## **CONSTRUCTION SUMMARY**

**Kingsmen (Thames) Inc. / Havelock Corners (Kingsmen)**

Lot/Unit: 219 Phase/Building: 4A Model/Floor Plan: Spencer (4204) Elev C 4 Bed - 4+1 Bath

### GROUND FLOOR EL. C

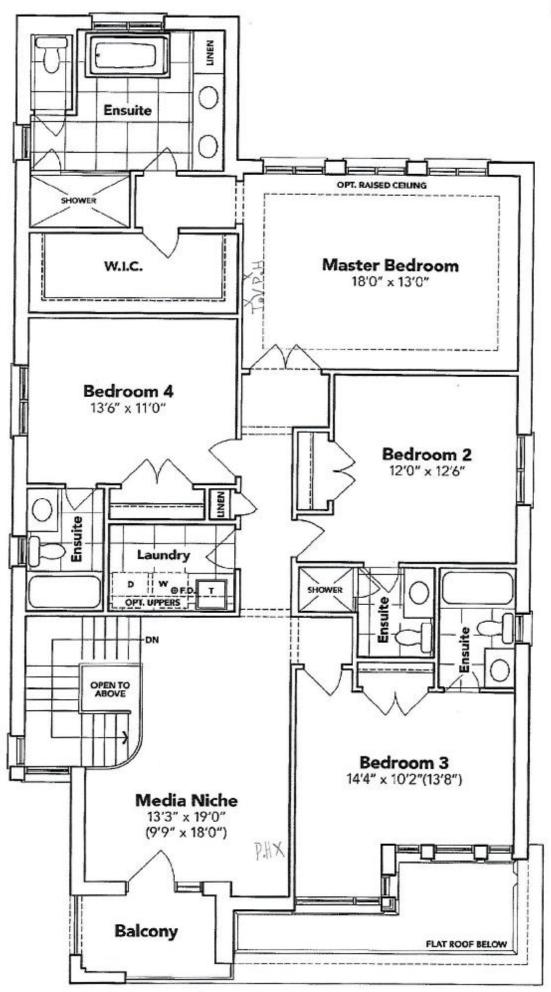
Inv. <b>5092</b>	1 - To supply and install the standard T.V Rough-in, in the Great Room and Master Bedroom	
	see sketch #1 and #2	
Line 66746	Note: To install the std. T.V. rough in in the great room at approx. 66" + - up from the floor centered + - to the F/P mantle	
24Aug21 / 25Aug21		
Inv. <b>5092</b>	1 - To supply and install the standard Phone (CAT 5) Rough-in, in the Great Room, Master	
	Bedroom and Media Niche see sketch #1 and #2	
Line 66747	Note: To install the std. Phone ( CAT 5 ) rough in in the great room at approx. 66" + - up from the floor centered + - to the F/P mantle	
24Aug21 / 25Aug21		
Inv. <b>5092</b>	1 - To SUPPLY AND INSTALL AN ADDITIONAL BASIC RECEPTACLE (NOT	
	DEDICATED) centered +- at approx. 66" up from the floor over the F/P Mantle in the Great	
	Room see sketch #1	
Line 66748	Note: To supply and install the standard Phone and T.V Rough-in next to the upg. elec outlet at approx. 66" up from the floor

Inv. <b>5092</b>	1 - To supply and install the standard coffered ceiling in the Dining Room, as per plan see sketch #1	
Line 66745	Note:	
24Aug21 / 25Aug21
